ERRATUM SHEET

Classification: **ERRATA: 1.0-ESC-2023:**
 Date: **19 DECEMBER 2023**
 Manual: **CPESC GENERAL PRINCIPLES REVIEW MANUAL, VERSION 7.0**

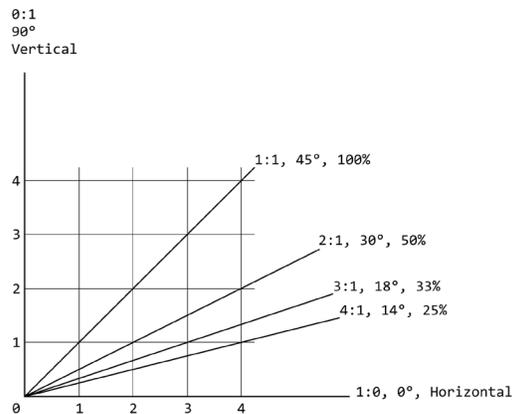
EXPLANATION OF CHANGE: Figure 7-22 Slope Description Methods on page 7-26 incorrectly shows a 2:1 slope as 30°, 50%.

CORRECTION: Figure 7-22 Slope Description Methods was updated to now present the following figures..
